**MOUNTAIN REGIONAL WATER SPECIAL SERVICE DISTRICT  
PARK CITY, UTAH**

**SIGNAL HILL WATER TREATMENT PLANT OPTIMIZATION**

**ENGINEER PROJECT NO. 203230**

**ADDENDUM NO. 2  
TO THE  
CONTRACT DOCUMENTS**

| VERIFY SCALES<br>BAR IS ONE INCH ON ORIGINAL DRAWING<br>0 1"<br>IF NOT ONE INCH ON THIS SHEET, ADJUST SCALES ACCORDINGLY | JOB NO.<br>203230<br>DRAWING NO.<br>40S04<br>SHEET NO.<br>85 OF 296 |

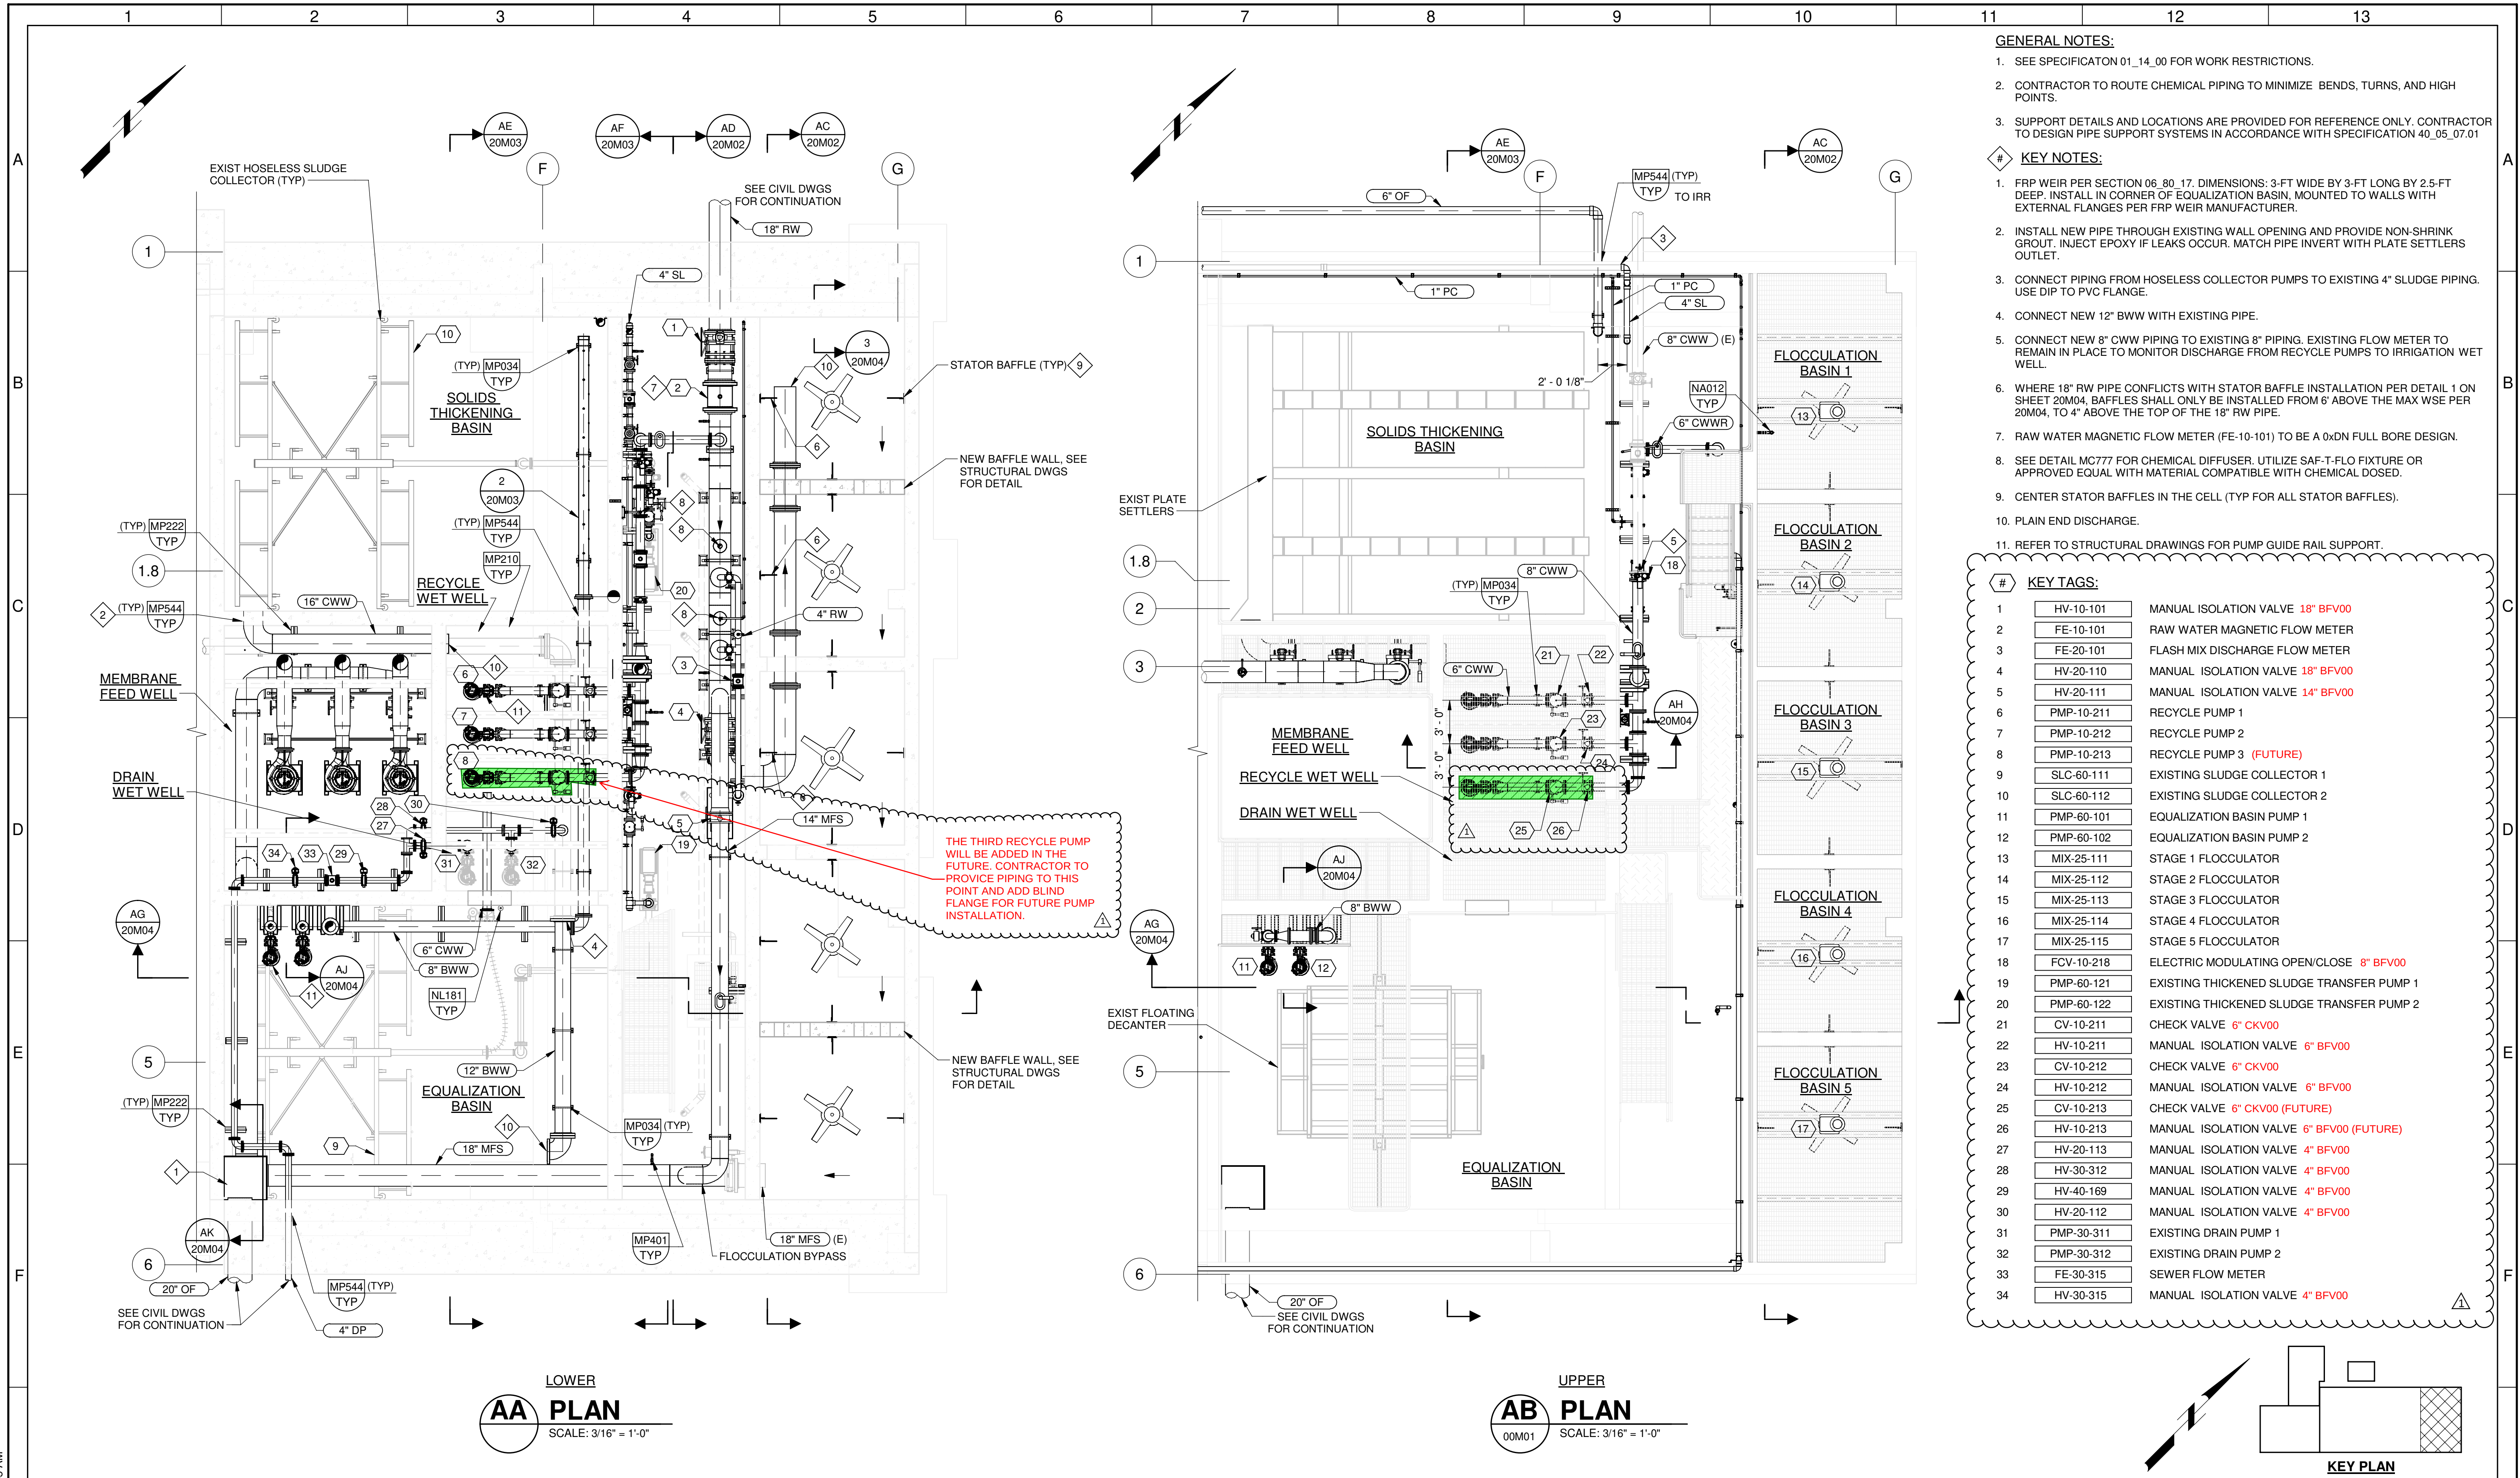
25. DRAWING 40S04:
  - a. REPLACE drawing in its entirety with the attached drawing.
26. DRAWING 70S02:
  - a. ADD General Note 3:
    - 1) "Access ladders to chemical containment areas and all grating and rebates in building should all be FRP per 06\_80\_17. FRP Rebates per typical detail SU605. Mezzanine access ladder and stairs should be aluminum per SR310 and SR226."

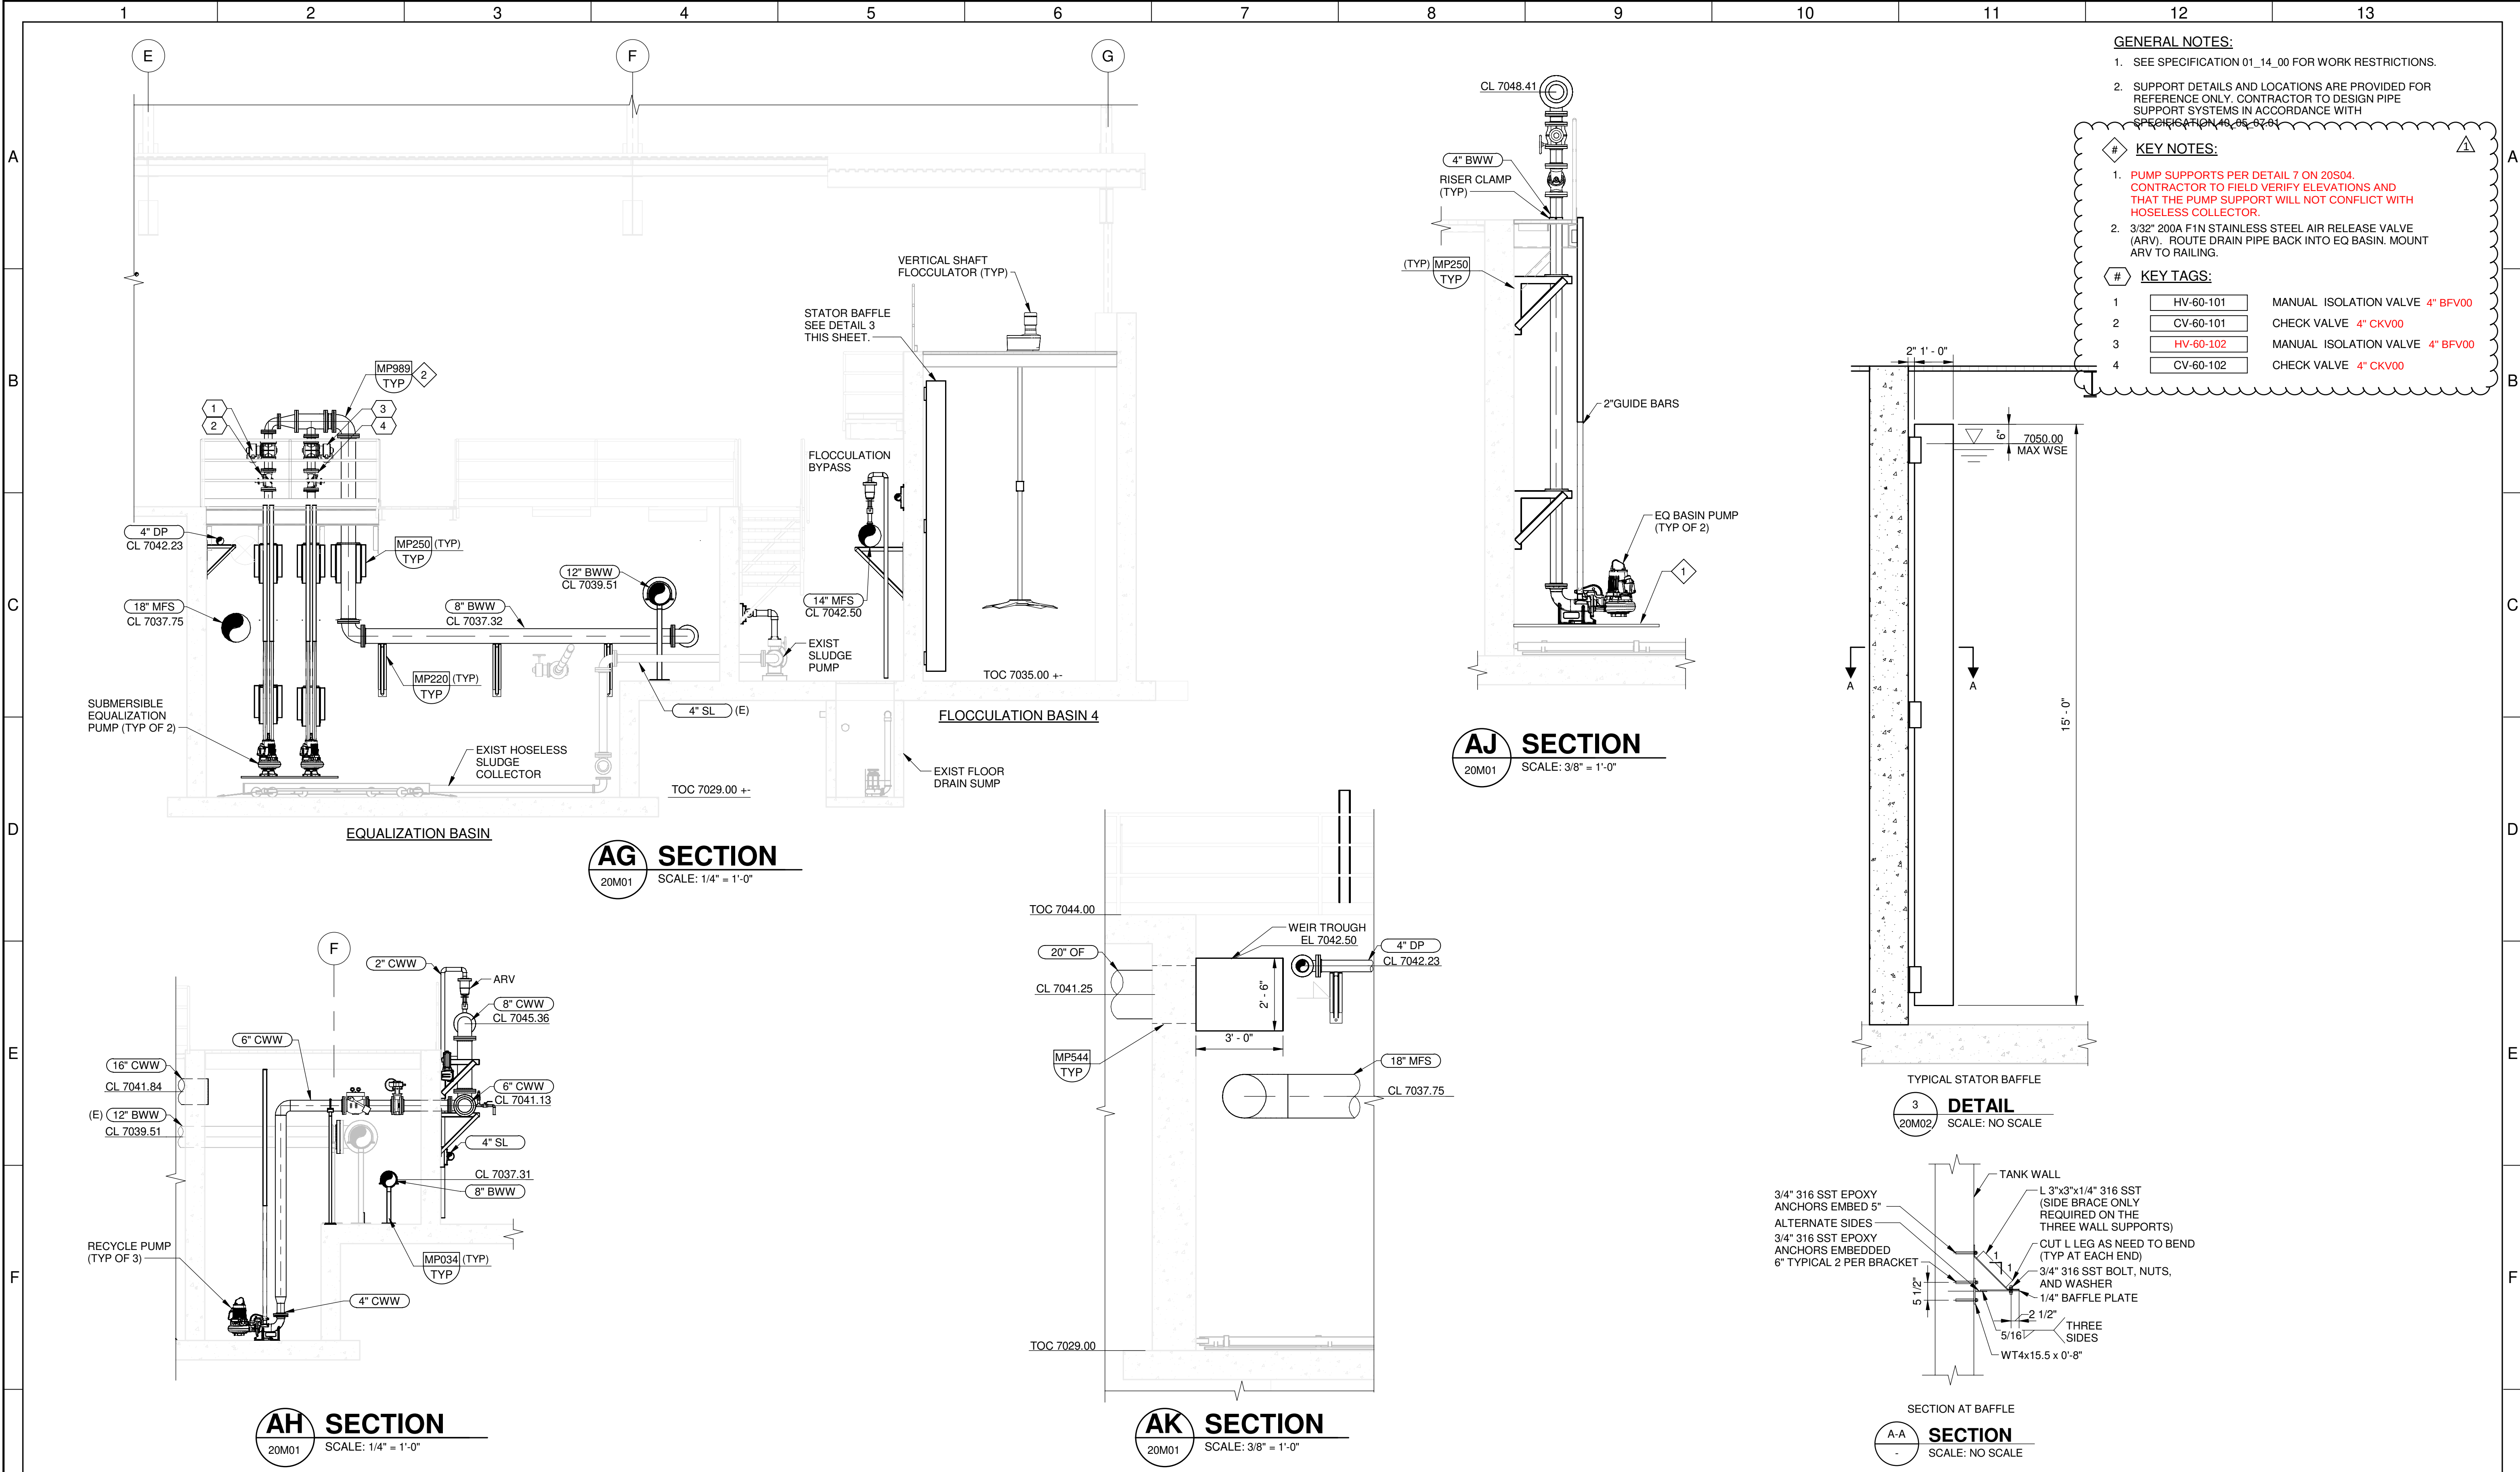
27. DRAWING 20M01:
  - a. REPLACE drawing in its entirety with the attached drawing.
28. DRAWING 20M02:
  - a. ADD valve specification ID "4-in BFV00" next to label for Key Tag 1 HV-20-106.
